A d d e n d u m

Iowa Department of Transportation
Office of Contracts

B.O.	Proposal ID	Proposal Work Type	County	Project Number	Addendum
011	97-3761-006-A	BRIDGE REPLACEMENT - PPCB	WOODBURY	BRF-376-1(6)--38-97	21JUN011.A02

ESTIMATED QUANTITIES AND NOTES

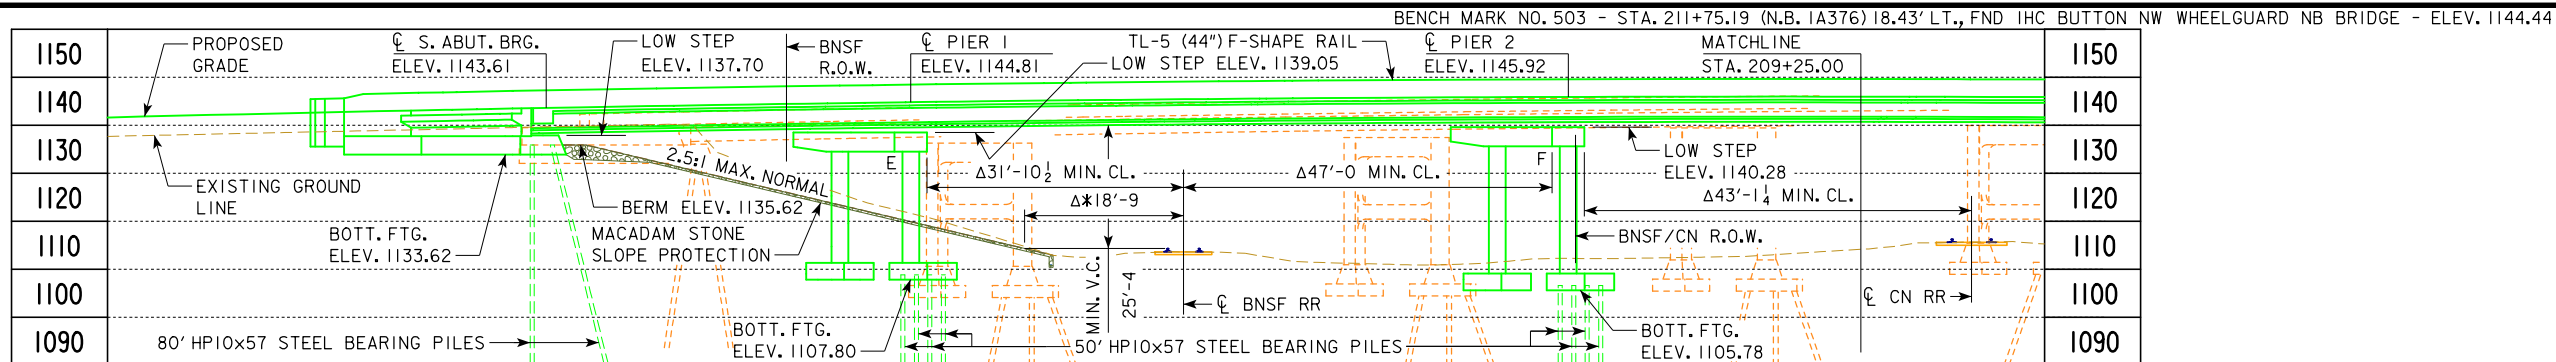
SHEET 2:

Change the following note of the GENERAL NOTES:

From: REMOVALS SHALL BE IN ACCORDANCE WITH SECTION 2401,
OF THE STANDARDSPECIFICATIONS.

To: REMOVALS SHALL BE IN ACCORDANCE WITH SECTION 2401,
OF THE STANDARDSPECIFICATIONS, EXCEPT THE REMOVAL
LIMIT FOR THE TWO EXISTING PIERS WITHIN THE CN R.O.W.
SHALL BE TAKEN AT THE TOP OF THE EXISTING PIER
FOOTINGS.

REMOVALS SHALL BE IN ACCORDANCE WITH SECTION 2401, OF THE STANDARD SPECIFICATIONS, EXCEPT THE REMOVAL LIMIT FOR THE TWO EXISTING PIERS WITHIN THE CN R.O.W. SHALL BE TAKEN AT THE TOP OF THE EXISTING PIER FOOTINGS.
